# High Pitch Whine Noise from Manual Transmission

YEAR(S)	MODEL(S)	ADDITIONAL INFORMATION
2016 - 2017	Tacoma	Transmission(s): 6MT

Some 2016 – 2017 model year Tacoma vehicles equipped with the 6 speed manual transmission (RC62F) may exhibit a high pitch whine noise when driving in 5<sup>th</sup> or 6<sup>th</sup> gear. A NEW heat insulator is available to address this condition.

**Figure 1.**

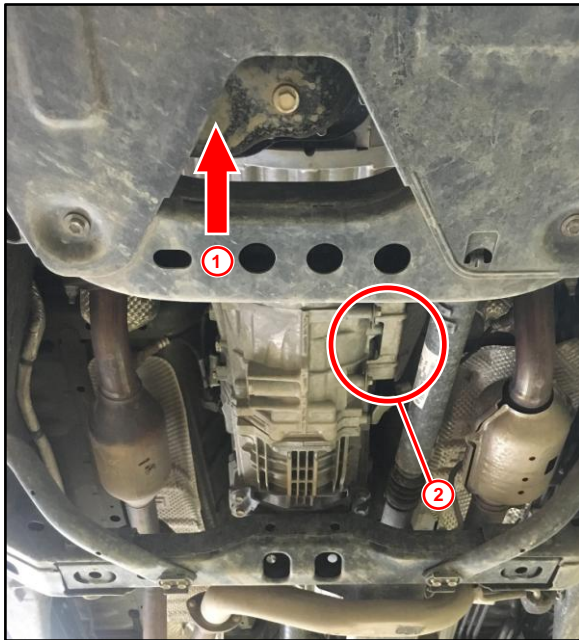
1. Does the vehicle exhibit a high pitch whine noise when driving in 5<sup>th</sup> or 6<sup>th</sup> gear?
  - **Yes** – Continue to step 2.
  - **No** – This bulletin does NOT apply. Continue diagnosis using the applicable Repair Manual.
2. Remove the 4 bolts and the Release Cylinder Heat Insulator from the manual transmission assembly.

**Figure 2.**

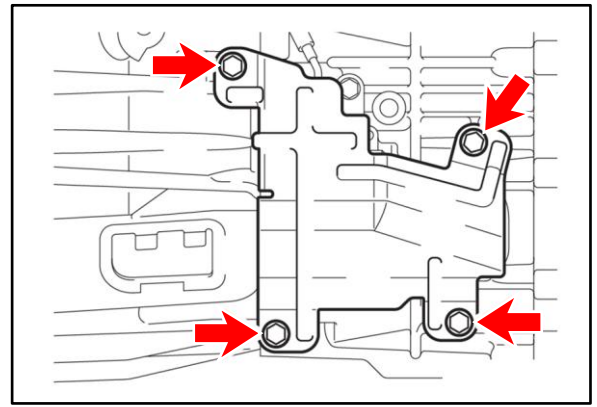
3. Install the NEW Release Cylinder Heat Insulator to the manual transmission assembly with 4 NEW bolts.  
**Torque: 12 N\*m (120 kgf\*cm, 9 ft\*lbf)**
4. Confirm proper vehicle operation and the high pitch whine is no longer present.
